REQUEST FOR TECHNICAL CHANGE

AGENCY: Building Code Council

RULE CITATION: 2012 NC Residential Code

2012 NC Residential, Building and Fire Codes
Docks, Piers, Bulkheads and Waterway Structures. (140610 Item B-14)

FIGURE 1: FIXED PIER WALKWAY SECTION

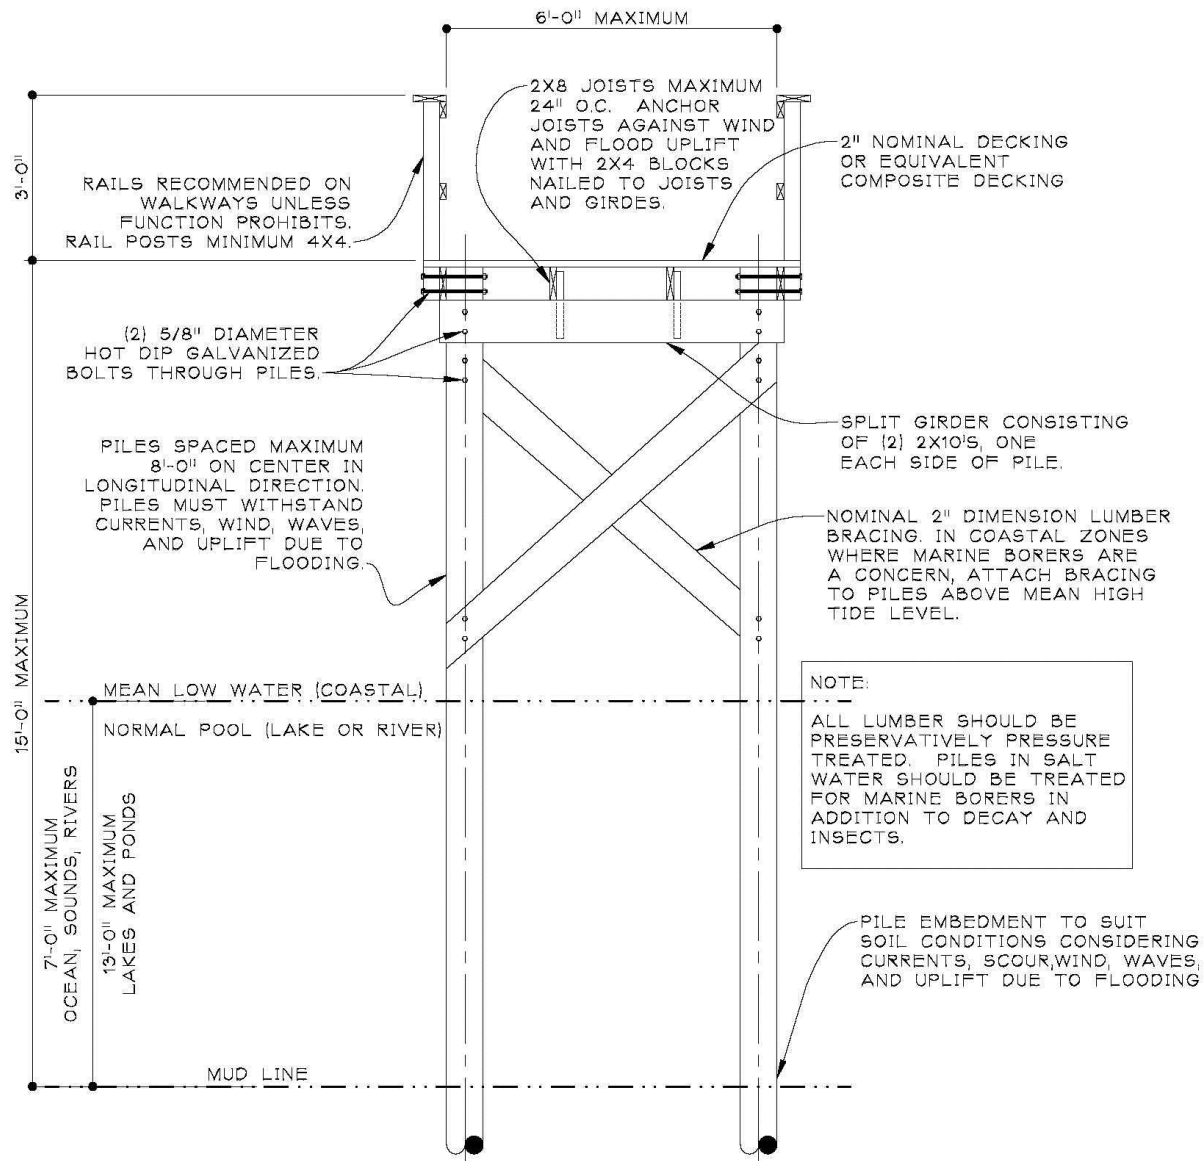
In Figures 1 and 3, in the Note beginning “All lumber should be,” I recommend replacing “should” with “shall”

FIGURE 4: GROUND SNOW LOADS

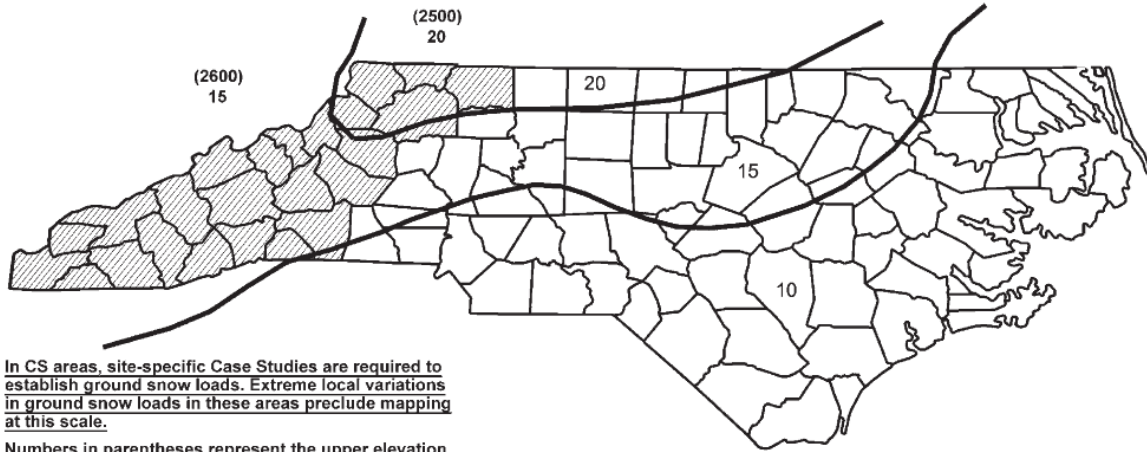
In Figure 4, what are “CS areas”? And what are the numbers not in parenthesis?
